ASUS FX506LI/FX506LH/FX706LI N18P-G62/G61 Block Diagram

Model
FX506LT
FX706LT

CHANGE LIST

Quanta Computer Inc.
PROJECT : FX506L/FX706L

eDP Conn.

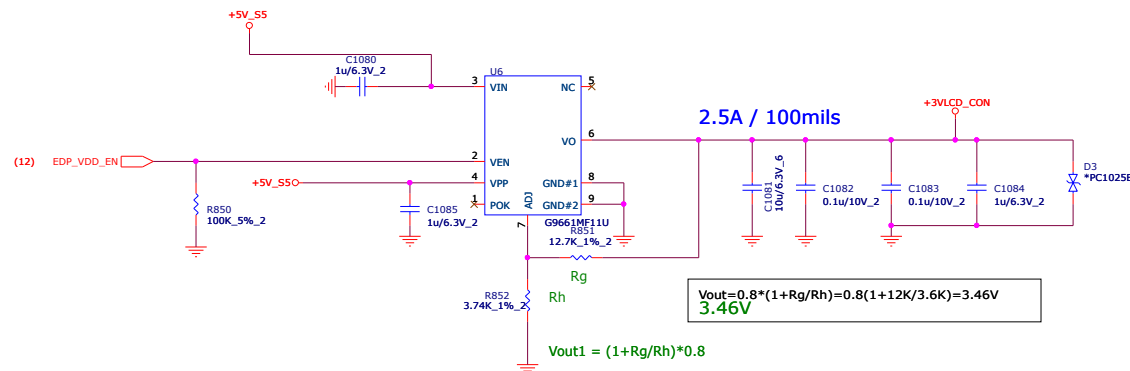
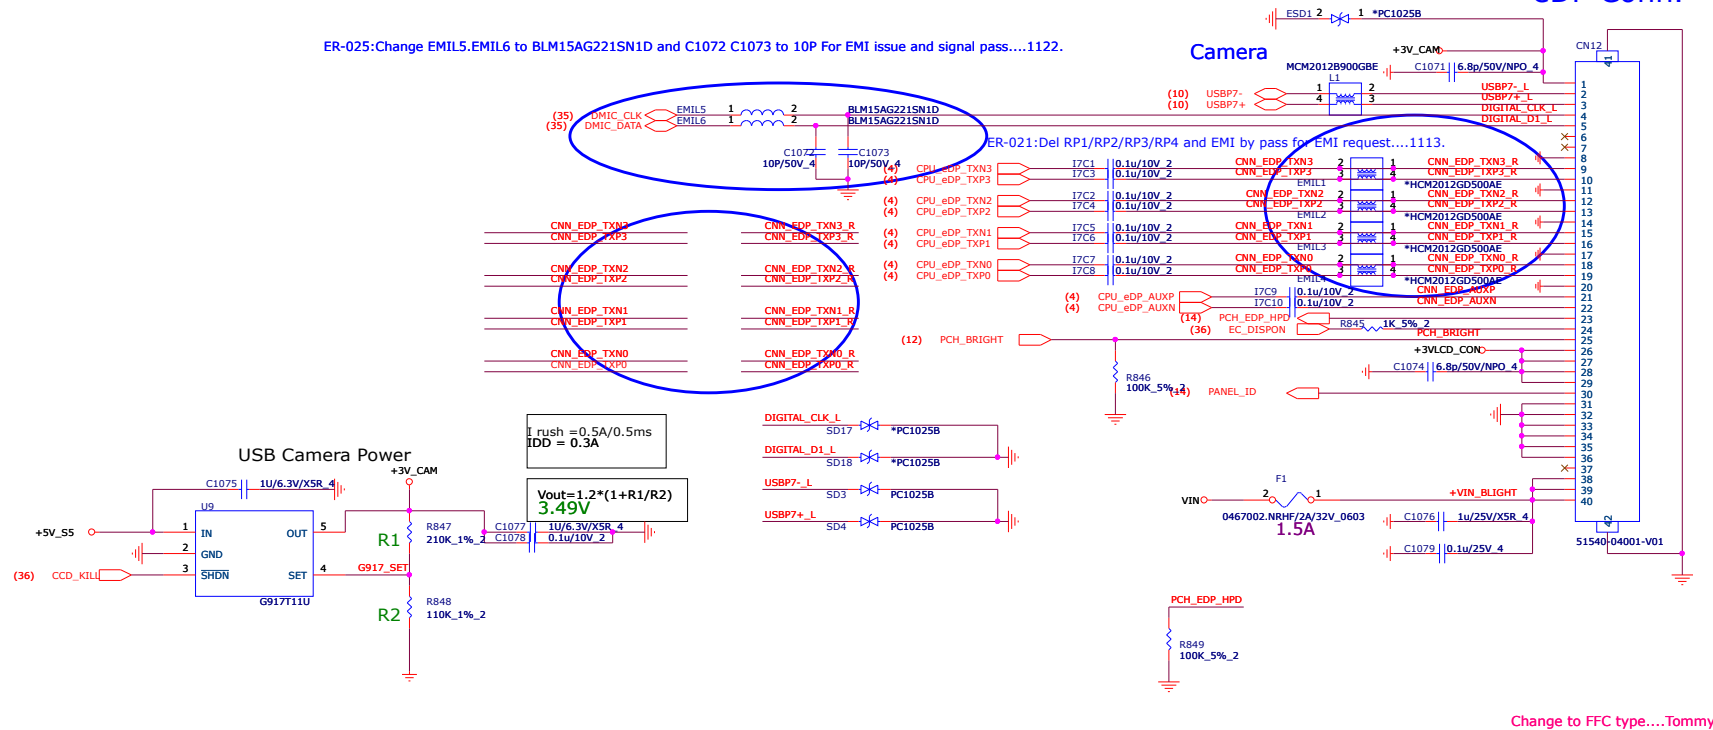
ER-025:Change EMIL5,EMIL6 to BLM15AG221SN1D and C1072 C1073 to 10P For EMI issue and signal pass....1122.

USB 3.2 GEN1 Type A/ PORT1

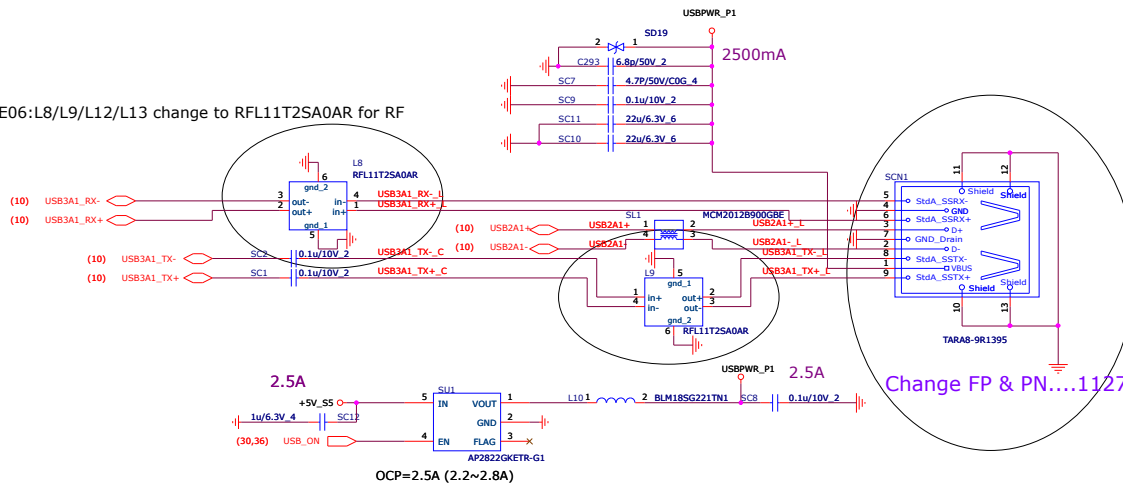
PR-E06:L8/L9/L12/L13 change to RFL11T2SA0AR for RF

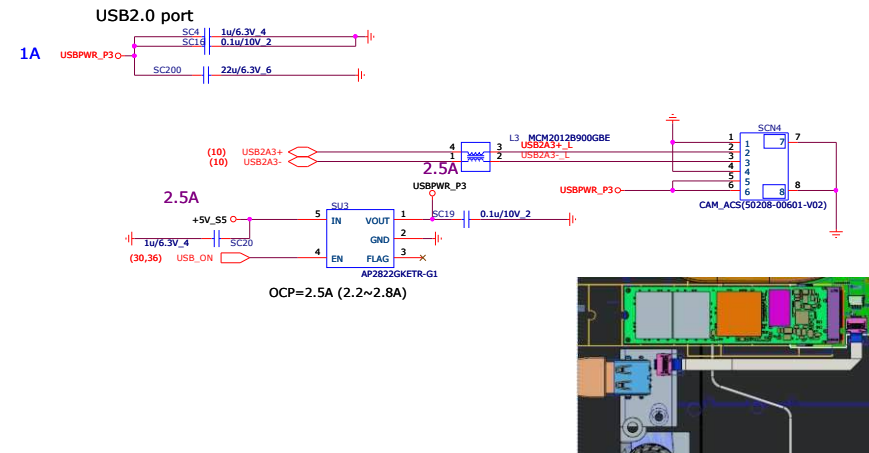
PR-E02:Remove CON6 for USB board FFC CONN.....0217

SATA HDD FFC

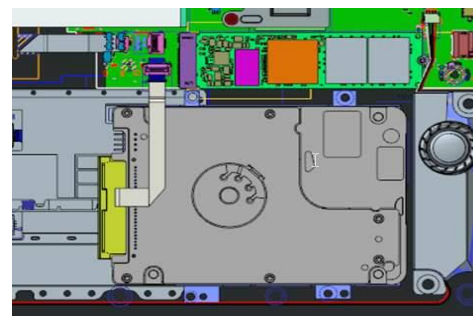
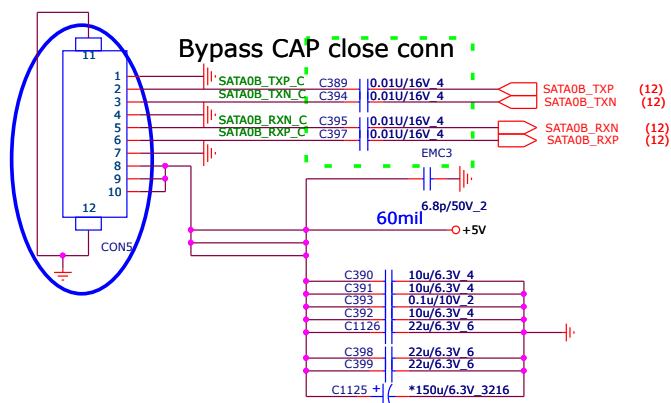
ER-032:Change HDD FFC pin define for ME cable routing....1126

Touch Pad Connector AA type

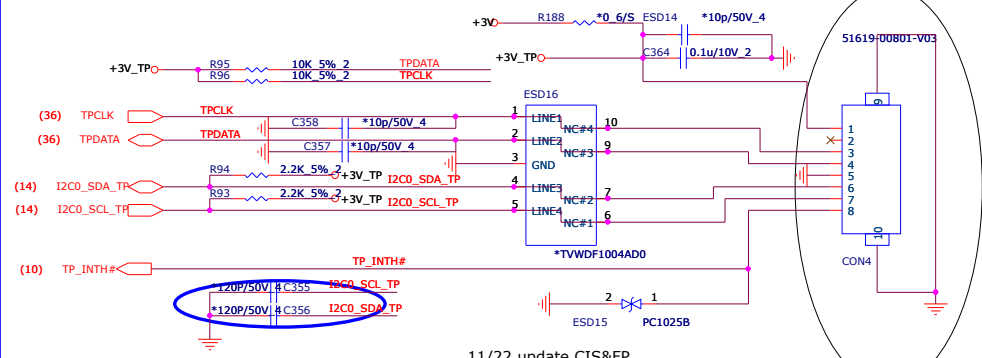
ER-029: Change C355,C356 to no-mount for fix TP timing issue....1122.

KEYBOARD Con.

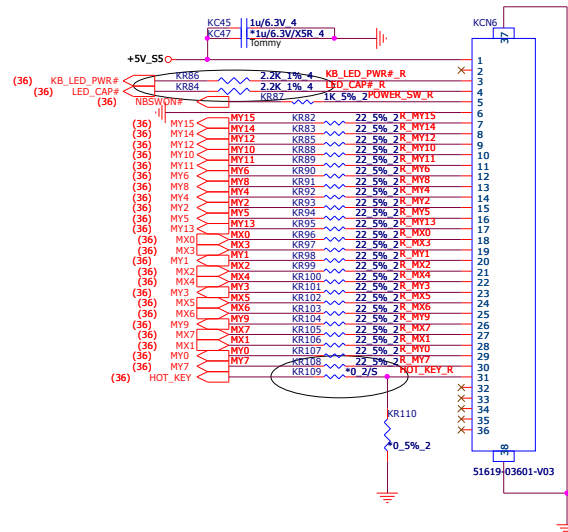
PR-E10:KR84, KR86 change from 220 ohm to 2.2K ohm for ID KB LED brightness request.

1 Zone R

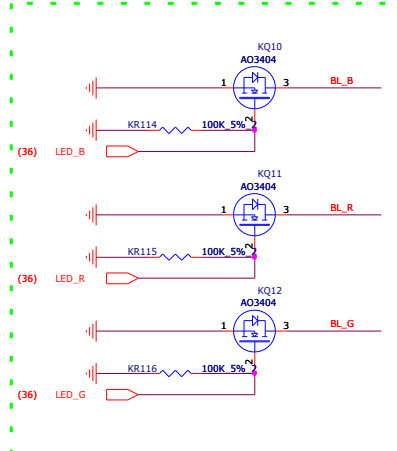
ER-031:Del KQ15/KQ13 for no support Red backlight....1125.

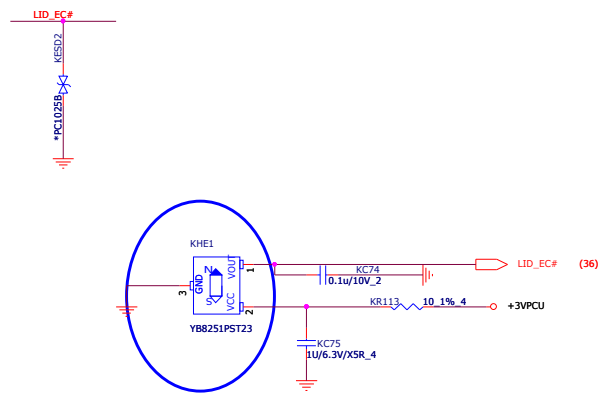
ER-033:Change footprint for SMT request....1126.
